SUBJECT: COMANCHE PEAK STEAM ELECTRIC STATION
DOCKET NOS. 50-445 AND 50-446
TMI ACTION PLAN ITEM II.F.2
ADDITIONAL INFORMATION

REF: TXX-4086 of January 3, 1984, a submittal
concerning CPSES implementation of TMI
Action Plan Item II.F.2

INSTRUMENTATION FOR DETECTION OF ADEQUATE CORE COOLING

FIG. 1 CORE EXIT THERMOCOUPLE TRAIN A
DISPLAYS (TRAIN B SIMILAR)

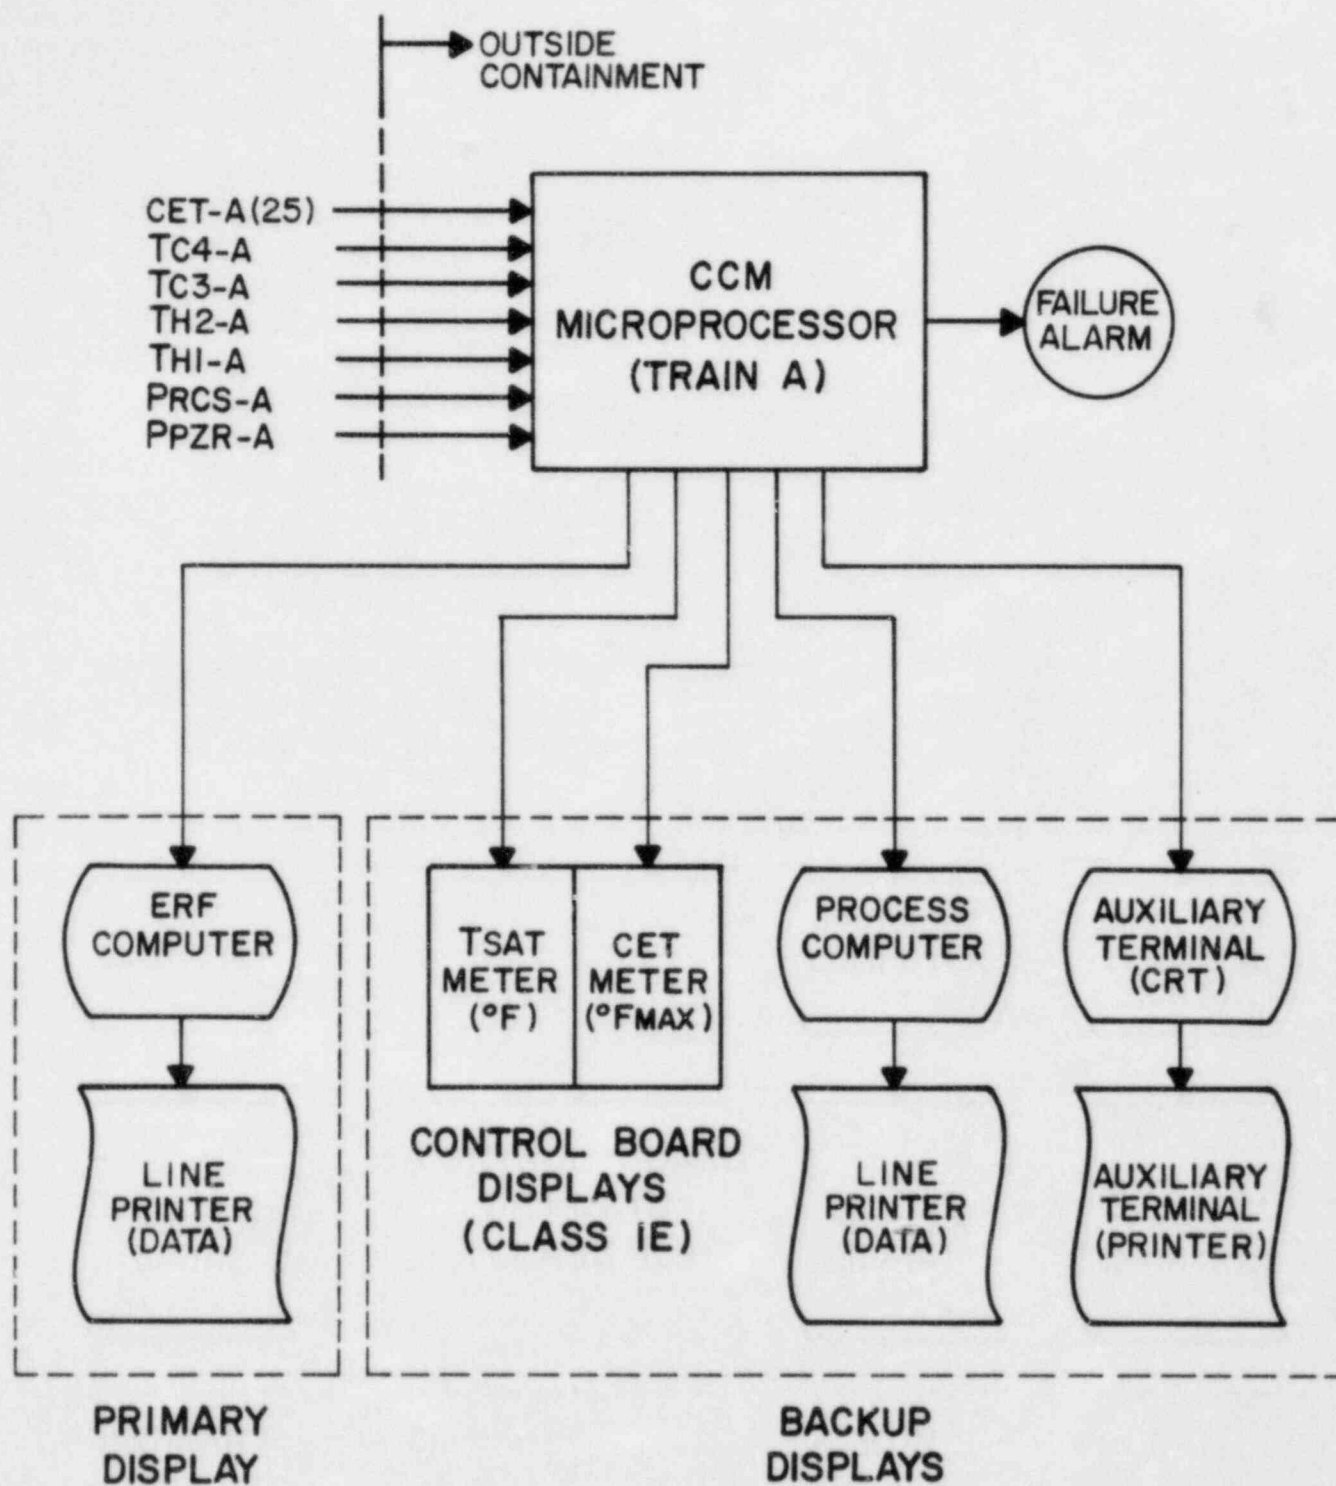
The attached figure illustrates the various displays available for use at CPSES to indicate plant status based on CET measurements. This illustration is intended to clarify the CCM-display information shown in Figure 4 of the previous report.
